**Proposal for the 02 series of amendments to the UN  
Regulation No.134 with regard to the safety-related  
performance of hydrogen-fuelled vehicles (HFCV) –  
consolidated text**

**Submitted by the task force amending UN Regulation No.134**

The text reproduced below was prepared by the task force involving France, Japan, the Netherlands, the European Commission, CLEPA and OICA as well as related industry experts in order to transpose the amendment 1 to UN Global Technical Regulation No. 13, Phase 2 (GTR13-PH2) into the UN regulation under the 1958 Agreement. The modifications to the existing text of the UN Regulation No, 134 are marked in bold for new or strikethrough for deleted characters.

Figure 1  
**Typical compressed hydrogen storage system**

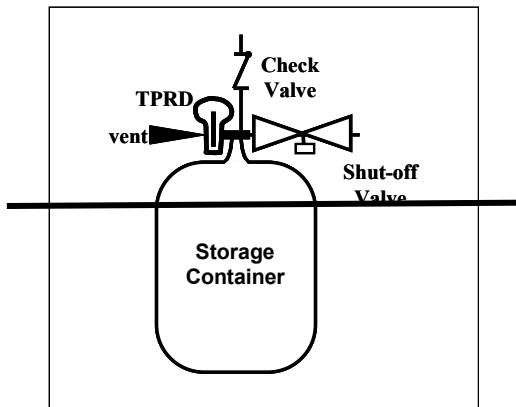
~~The hydrogen storage system consists of the high pressure storage container and primary closure devices for openings into the high pressure storage container. Figure 1 shows a typical compressed hydrogen storage system consisting of a pressurized container, three closure devices and their fittings. The closure devices shall include the following functions, which may be combined:~~

- ~~(a) TPRD;~~
- ~~(b) Check valve that prevents reverse flow to the fill line; and~~
- ~~(c) Automatic shut-off valve that can close to prevent flow from the container to the fuel cell or internal combustion engine. Any shut-off valve, and TPRD that form the primary closure of flow from the storage container shall be mounted directly on or within each container. At least one component with a check valve function shall be mounted directly on or within each container.~~

- (a) **The primary closure devices shall include the following functions, which may be combined:**
  - (i) **TPRD;**
  - (ii) **Check valve; and**
  - (iii) **Shut-off valve**

- (b) The primary closure devices shall be mounted directly on or within each container. [If needed, manufacturers may choose to locate additional TPRDs in alternative locations on the container. However, any additional TPRDs should be connected directly to the container by using supply lines that have demonstrated mechanical integrity and durability as part of qualification tests for the CHSS (i.e., pneumatic sequential test in paragraph 5.3., fire test in paragraph 5.4. and verification of closure durability in paragraph 6.1.) as well as the specific loads related to the integration of this components to the vehicle (i.e. crash, vibration).]

Figure 12  
Verification test for performance durability (hydraulic)

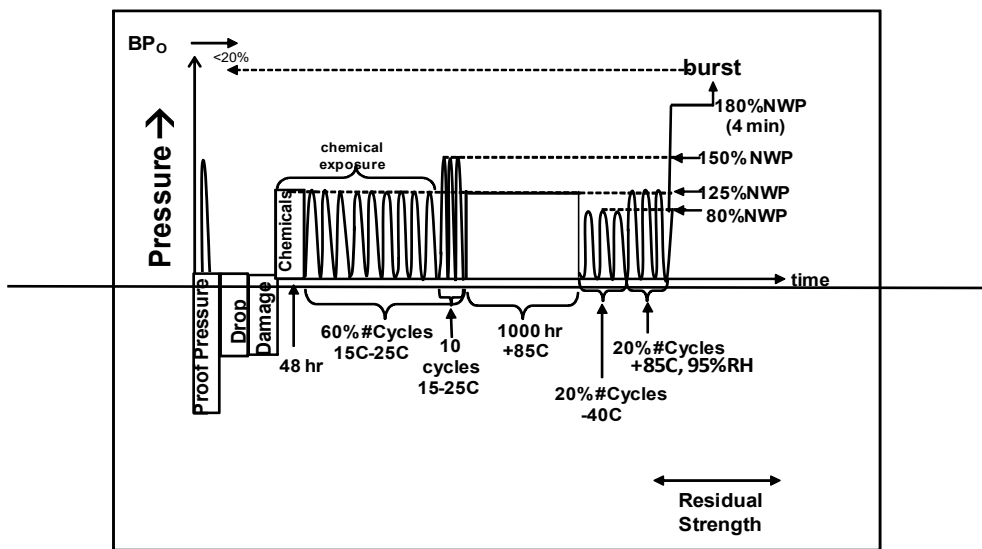
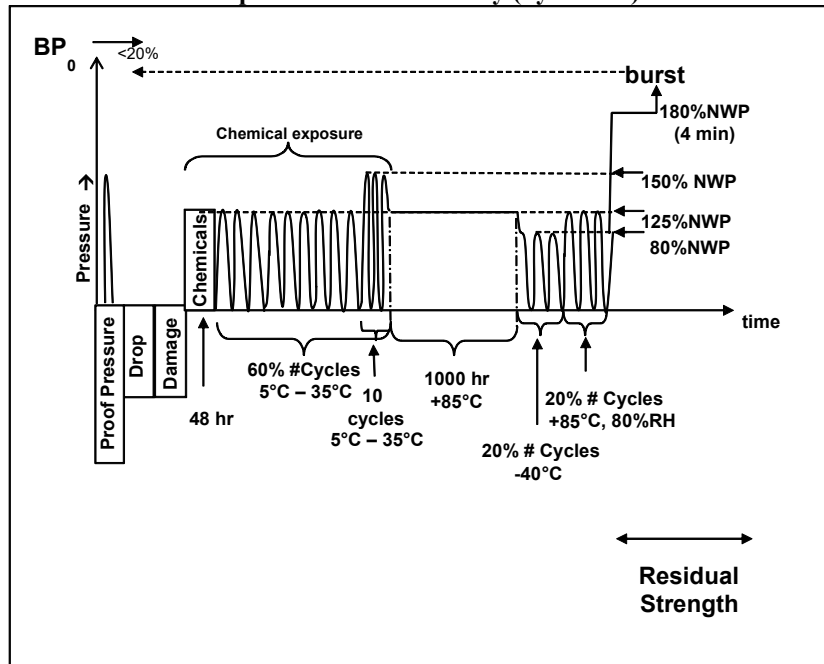
If all three pressure cycle life measurements made in paragraph 5.1.2. are greater than 11,000 cycles ~~for a 15 year service life or 15,000 cycles for a 20-year service life~~, or if they are all within  $\pm 25$  per cent of each other, then only one (1) container is tested in paragraph 5.2. Otherwise, three (3) containers are tested in paragraph 5.2.

**Unless otherwise specified, the tests in paragraph 5.2 shall be conducted on the container equipped with its container attachments (if any) that represents the CHSS without the primary closures.**

~~A hydrogen storage system~~ **The** container shall not leak during the following sequence of tests, which are applied in series to a single system and which are illustrated in Figure 12. Specifics of applicable test procedures ~~for the hydrogen storage system~~ are provided in Annex 3, paragraph 3.

Figure 23  
Verification test for expected on-road performance (pneumatic/hydraulic)

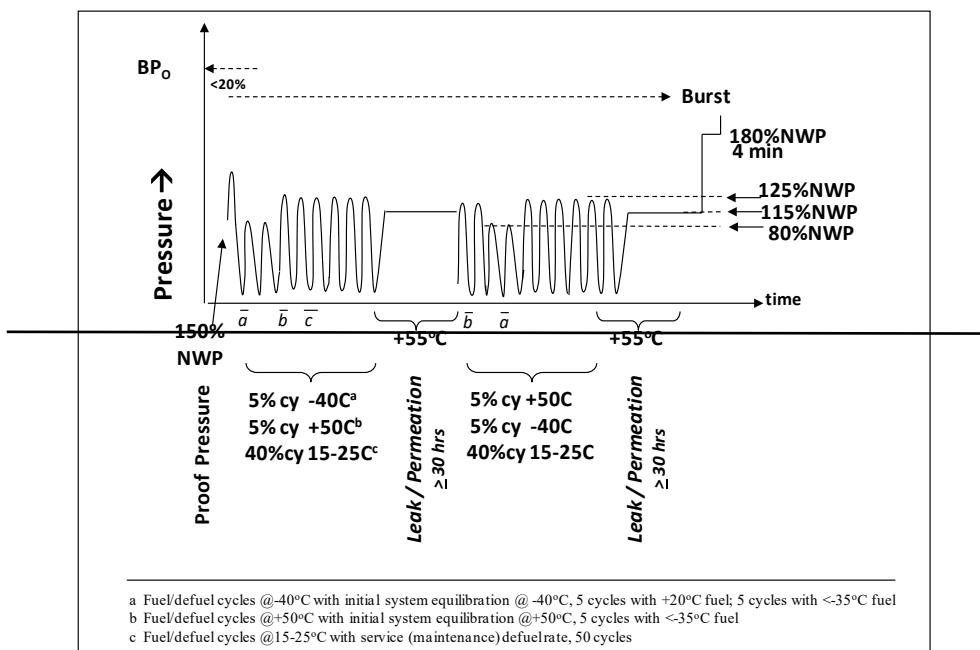
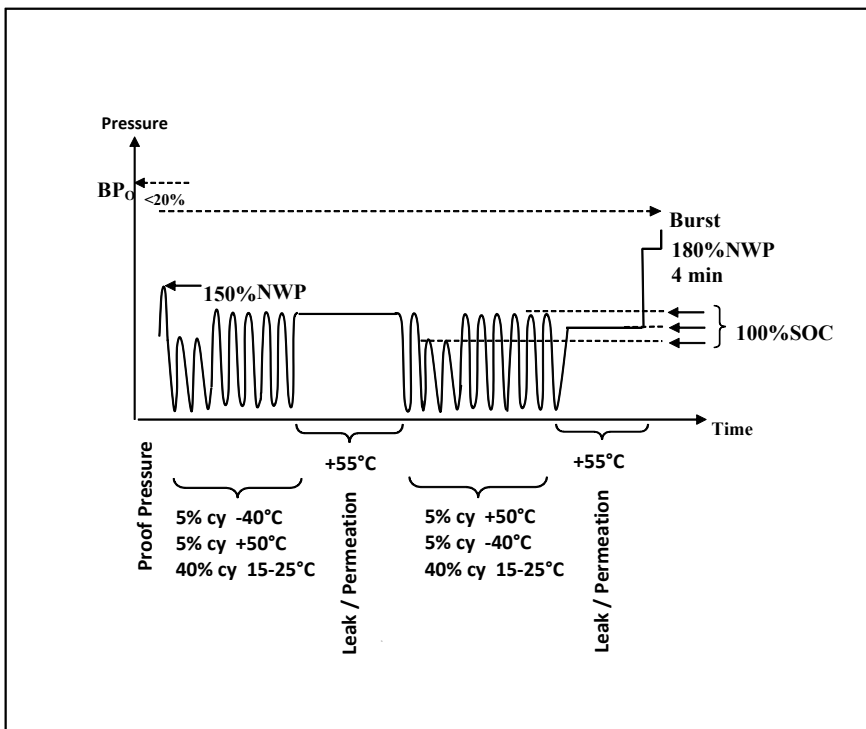
A ~~hydrogen storage system~~ CHSS shall **undergo not leak** during the following sequence of tests, which are illustrated in Figure 23. Specifics of applicable test procedures for the ~~CHSS hydrogen storage system~~ CHSS are provided in Annex 3.

The CHSS shall not leak and the primary closure devices shall maintain functionality during the test.

Figure 1  
Drop orientations

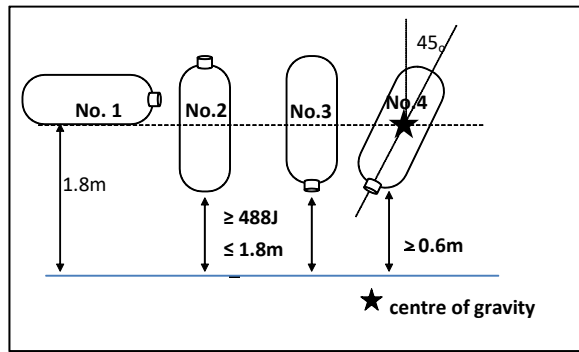
- (iv) ~~Dropped once at~~ From a 45° angle from the vertical orientation with **the shut-off valve interface location** ~~a ported end~~ downward with its centre of gravity  $\leq 1.8$  m above the ground. However, if the bottom is closer to the ground than 0.6 m, the drop angle shall be changed to maintain a minimum height of 0.6 m and a centre of gravity of  $\leq 1.8$  m above the ground. **In case of non-axisymmetric container, the line passing the shut-off valve interface location end and its centre of gravity shall be 45° angled from vertical orientation and the shut-off valve interface location shall become the lowest.**

The four drop orientations are illustrated in Figure 1.

Figure 2  
Surface damage flow chart

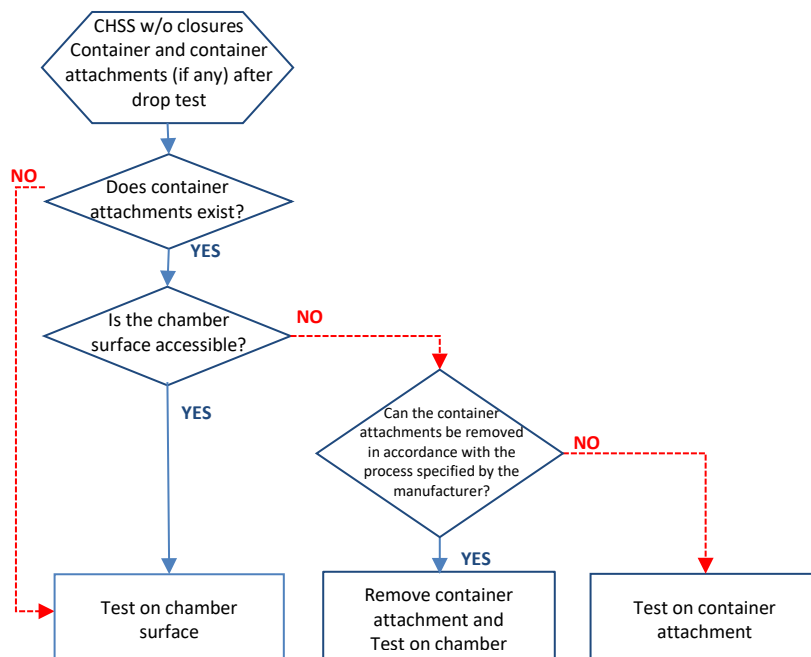
If the container attachments can be removed in accordance with the process specified by the manufacturer, then the container attachments shall be removed, and the tests shall be conducted on the surface of the pressure bearing chamber of the container.

Otherwise, the tests shall be conducted on the surface of the container attachments as indicated in Figure 2.

**Figure 4**  
Temperature profile of fire test

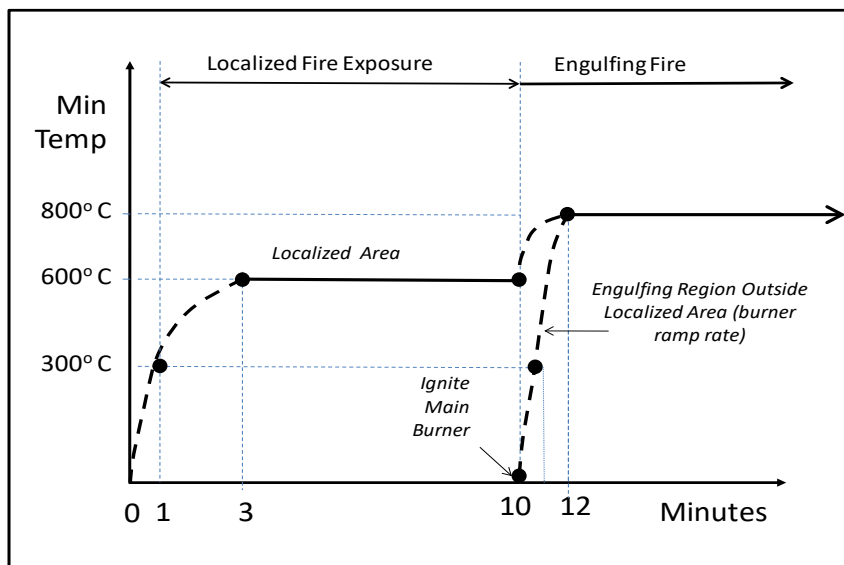
The test consists of two stages: a localized fire stage followed by an engulfing stage as described in Figure 4.

Figure 3  
Temperature profile of fire test

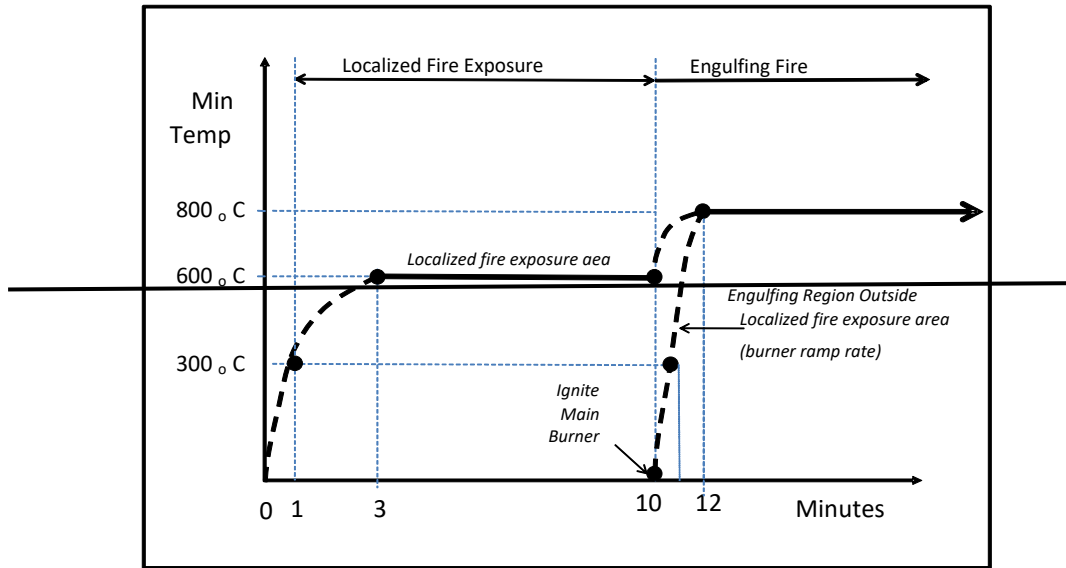
- ~~(iii) Wind shields are applied to ensure uniform heating;~~
    - ~~(iv) The fire source initiates within a 250 ( $\pm 50$ ) mm longitudinal expanse positioned under the localized fire exposure area of the test article. The width of the fire source encompasses the entire diameter (width) of the storage system. If Method 2 is selected, the length and width shall be reduced, if necessary, to account for vehicle specific features;~~

- ~~(v) As shown in Figure 3 the temperature of the thermocouples in the localized fire exposure area has increased continuously to at least 300°C within 1 minute of ignition, to at least 600°C within 3 minutes of ignition, and a temperature of at least 600°C is maintained for the next 7 minutes. The temperature in the localized fire exposure area shall not exceed 900°C during this period. Compliance to the thermal requirements begins 1 minute after entering the period with minimum and maximum limits and is based on a 1-minute rolling average of each thermocouple in the region of interest. (Note: The temperature outside the region of the initial fire source is not specified during these initial 10 minutes from the time of ignition.);~~~~
